I, Genevieve L. Donart, NMPE, of the firm Isaacson & Arfman, P.A., hereby certify that this project has been graded and will drain in substantial compliance with and in accordance with the design intent of the approved plan dated 11/13/2014. The record information edited onto the original design document has been obtained by a licensed surveyor as noted in the table below. I further certify that I have personally visited the project site on the date below and have determined by visual inspection that the survey data provided is representative of actual site conditions and is true and correct to the best of my knowledge and belief with the following exceptions:

INNOVA PLAZA - SITE DEVELOPMENT
GRADING & DRAINAGE PLAN
401 EUBANK SE, ALBUQUERQUE, NM 87123
PROJECT #1459

INNOVA PLAZA - SITE DEVELOPMENT
OVERALL SITE PLAN
401 EUBANK SE, ALBUQUERQUE, NM 87123
PROJECT # 1459

BASIN MAP SCALE: 1"=60'

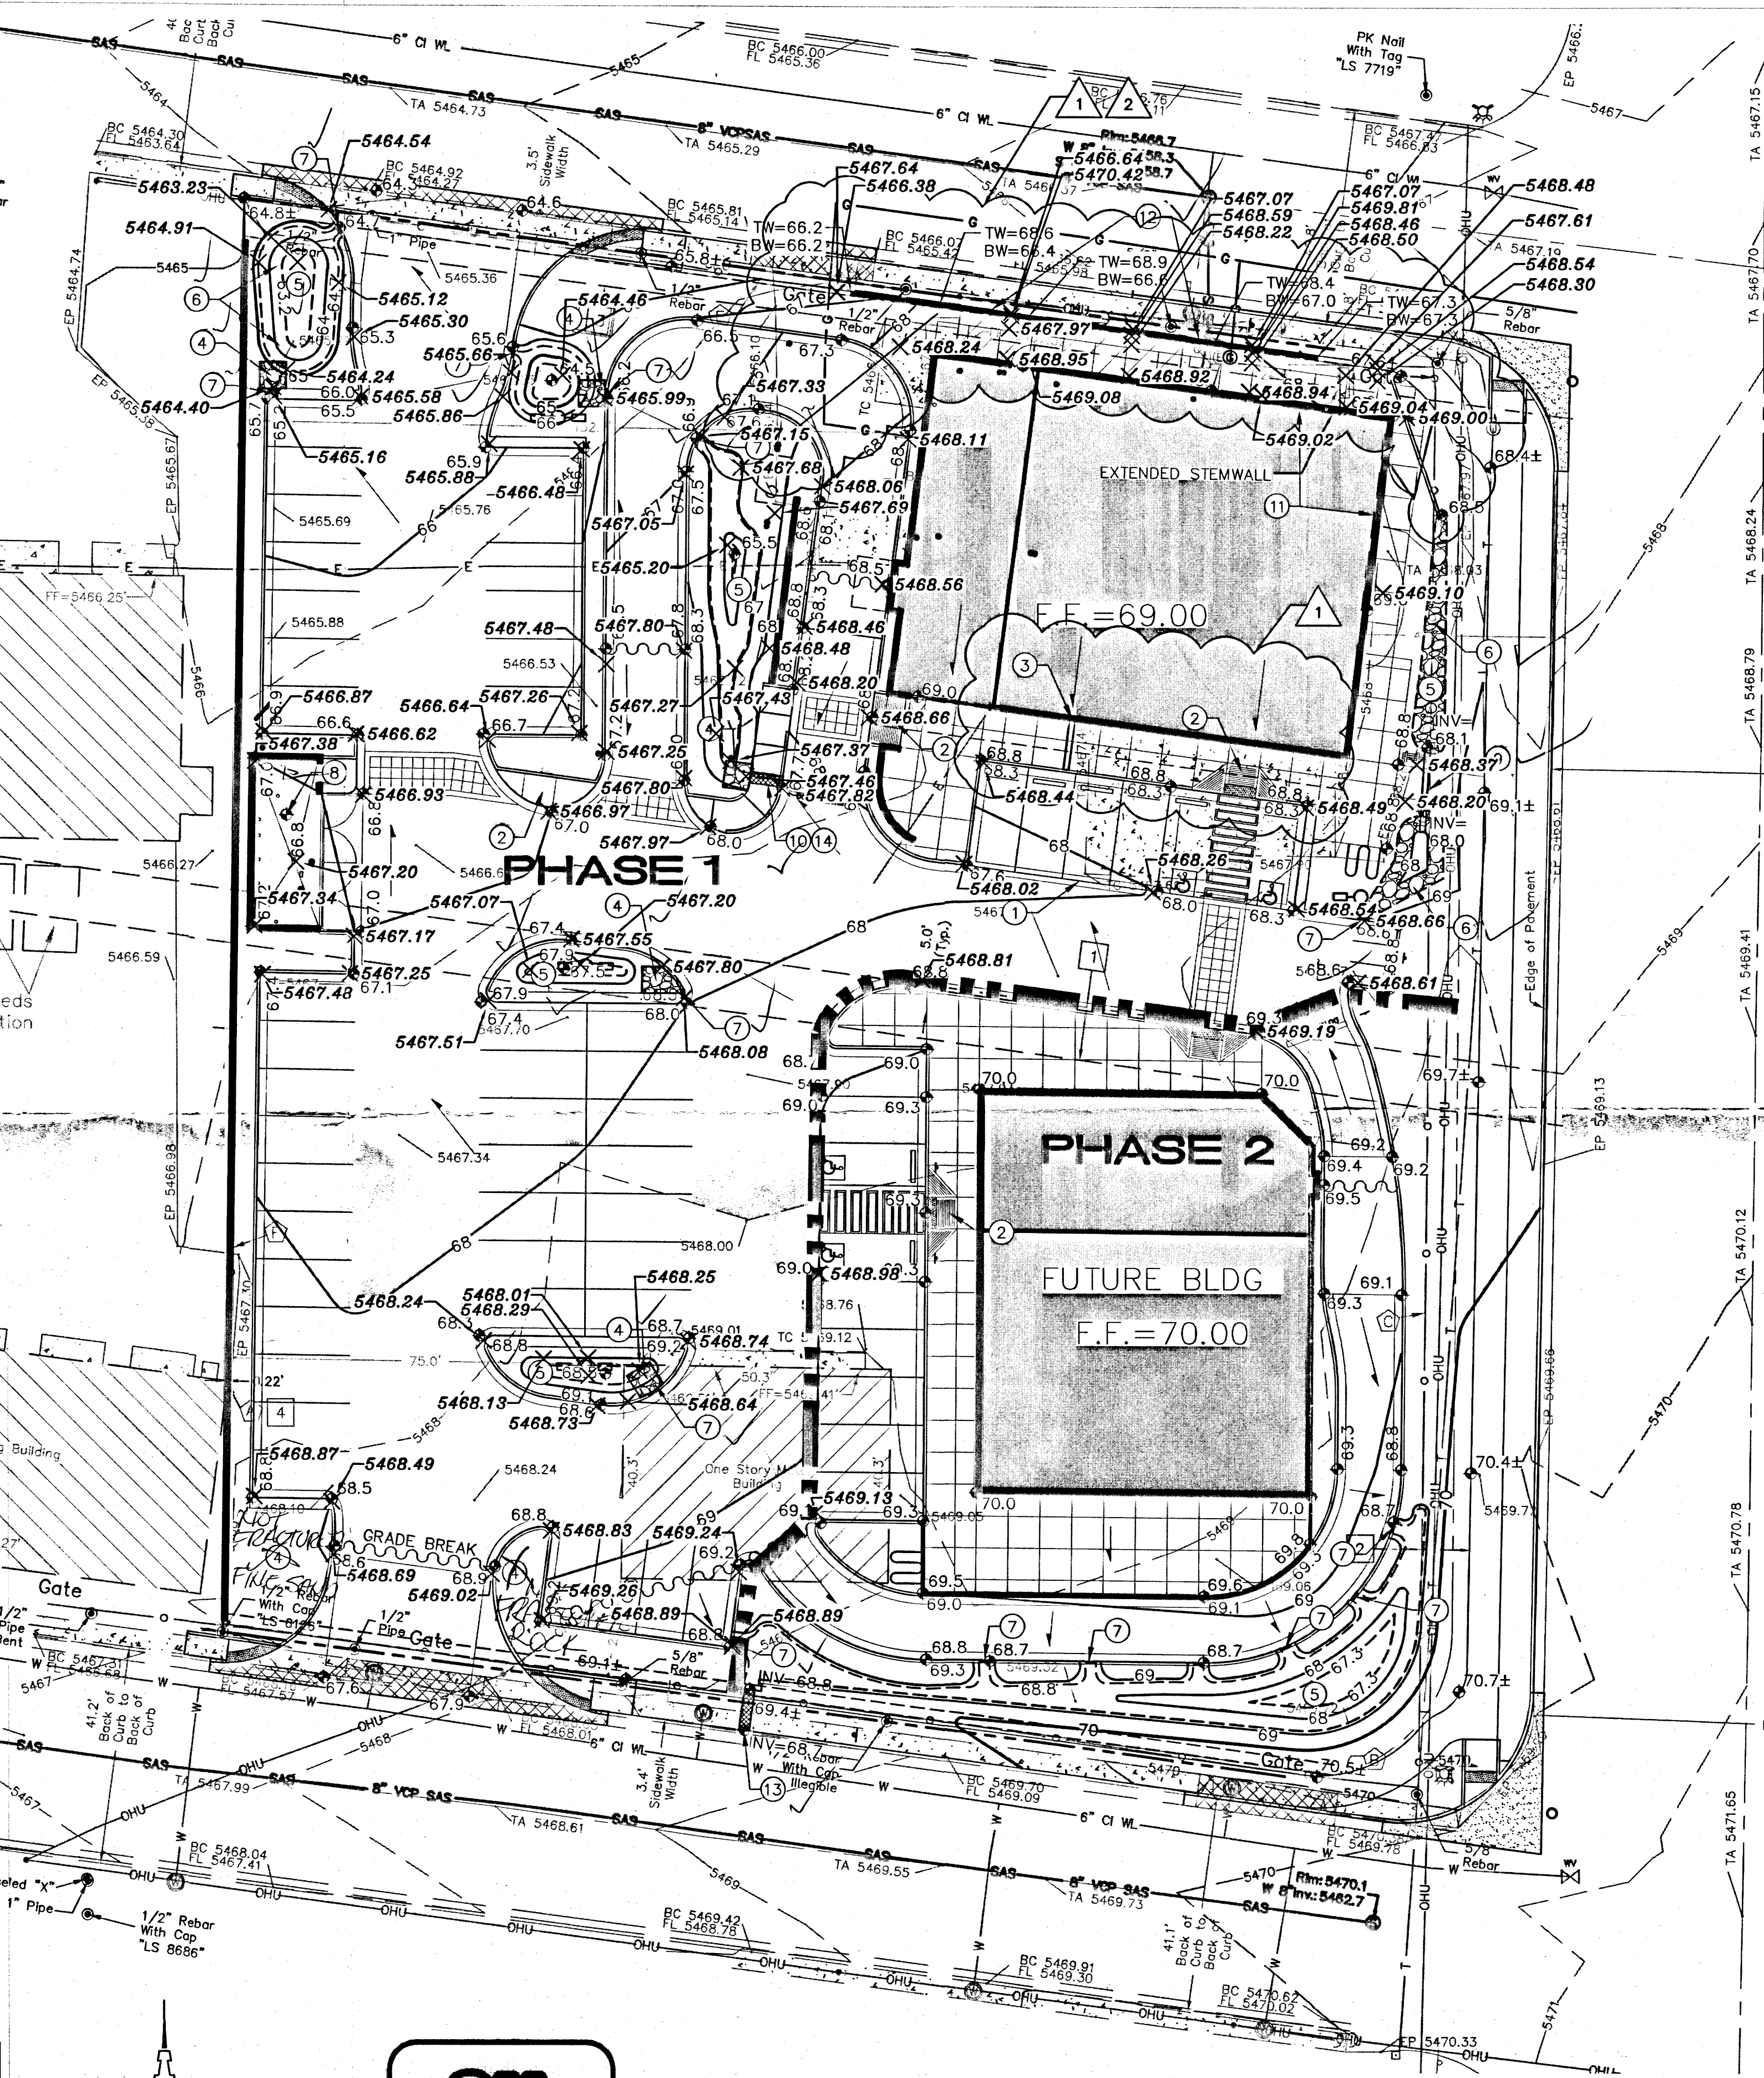
- PHASE 1:**
- Roof drains were directed to the back (north) of the building instead of the front (south). To accommodate this drainage, trench drains were placed across the sidewalk, a concrete swale was installed between the sidewalk and retaining wall. Water from this swale was captured in 3" pipes, and directed to two of the designed ponds.
 - Exterior doors were added along the north side of the building. The sidewalk was lifted, and the retaining wall extended to the east.
- PHASE 2:**

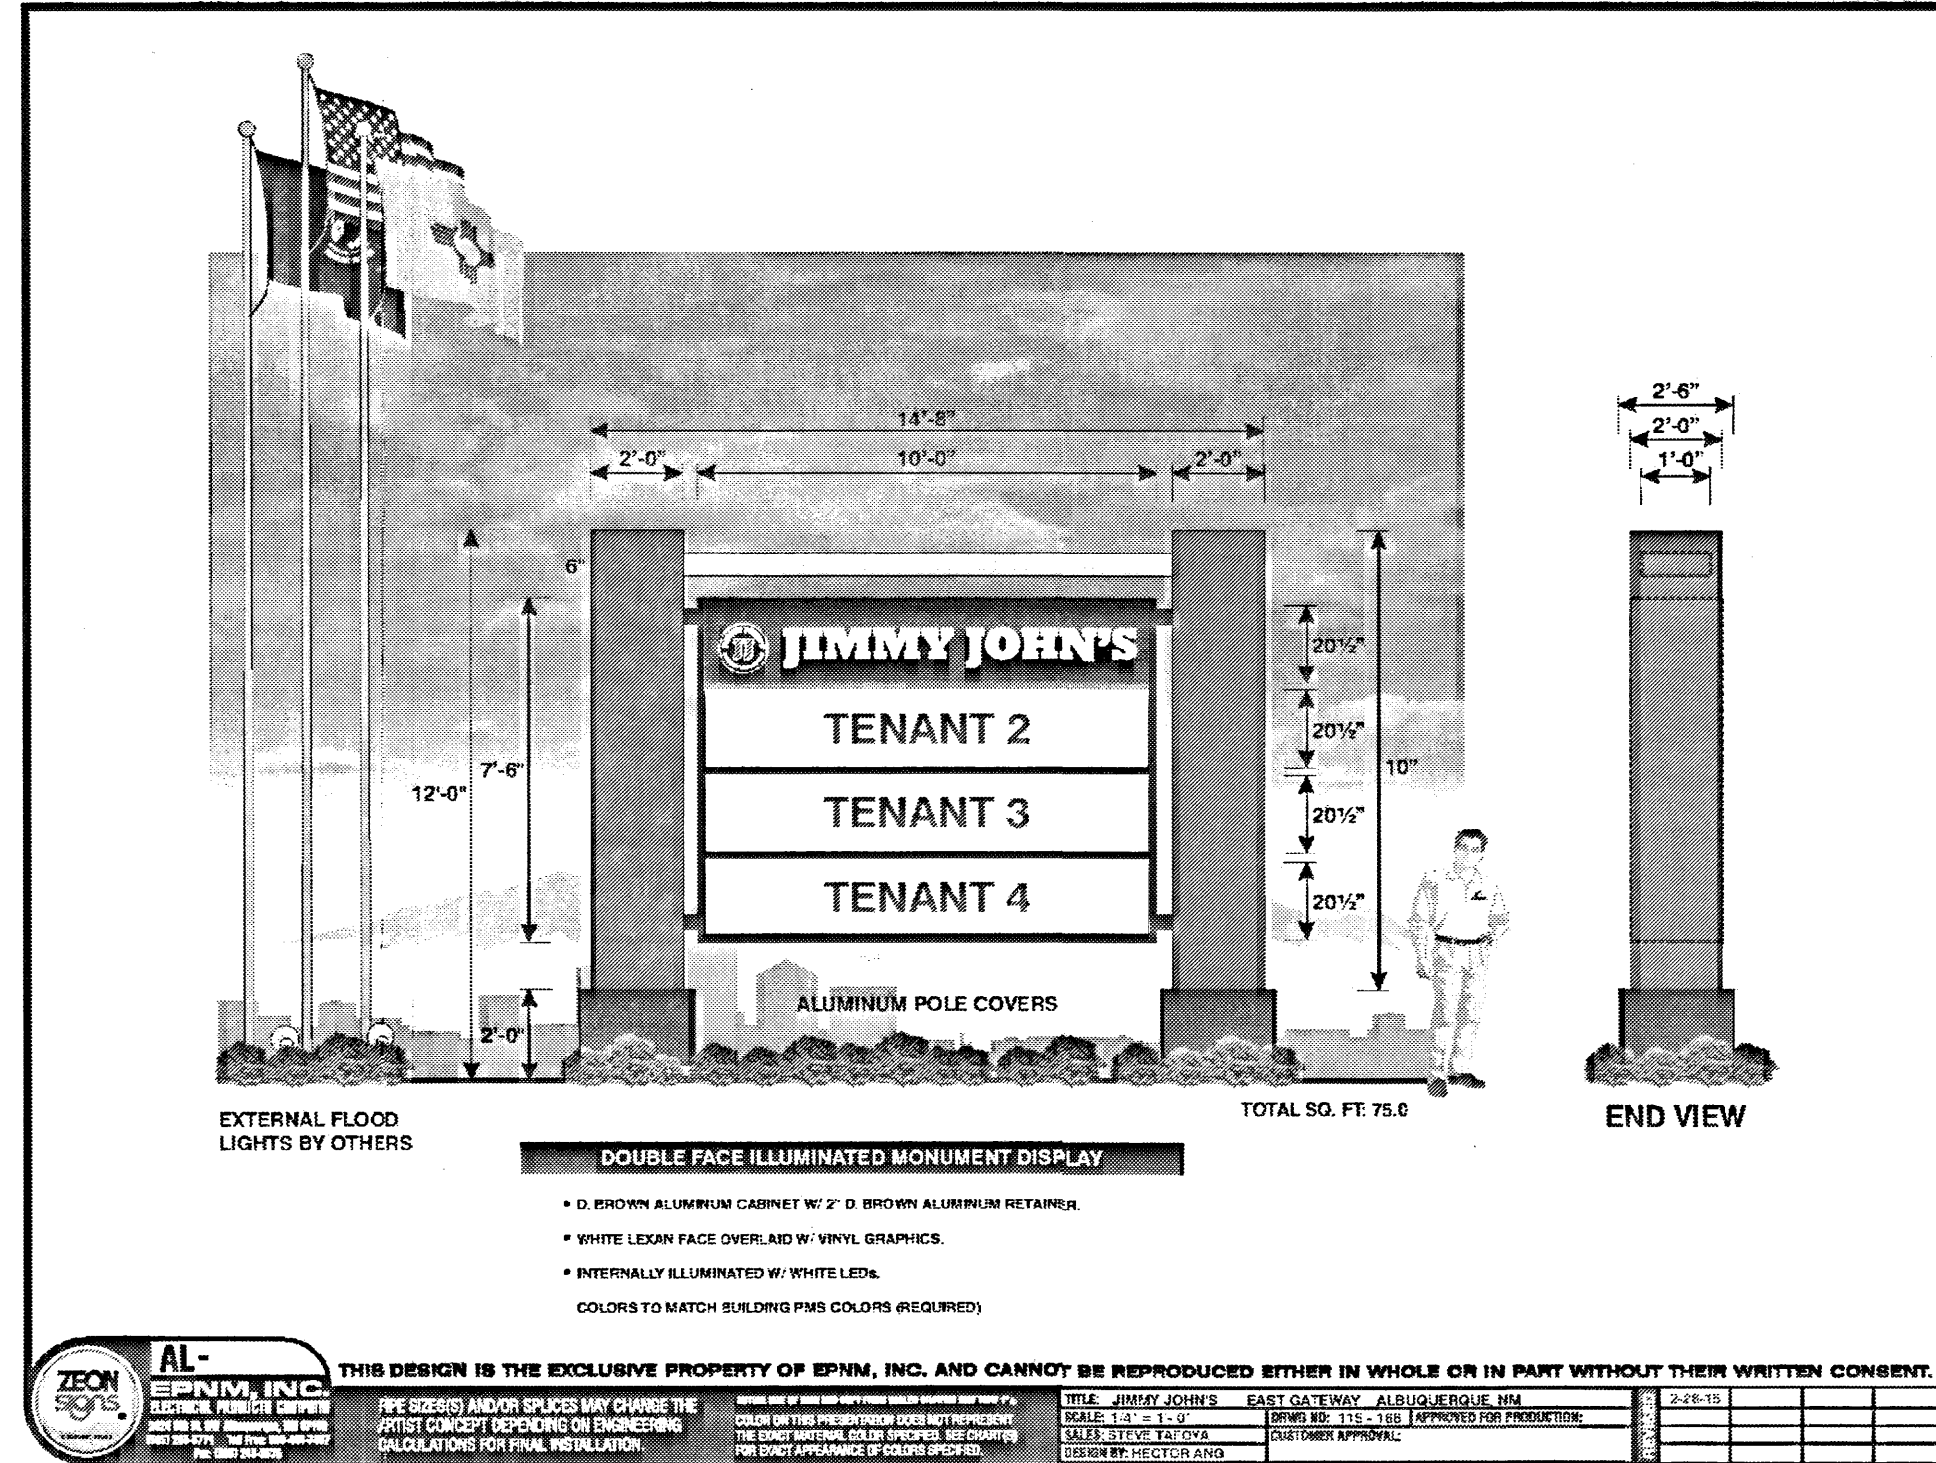
MC parking?
It appears to need replat => DRB
traffic path
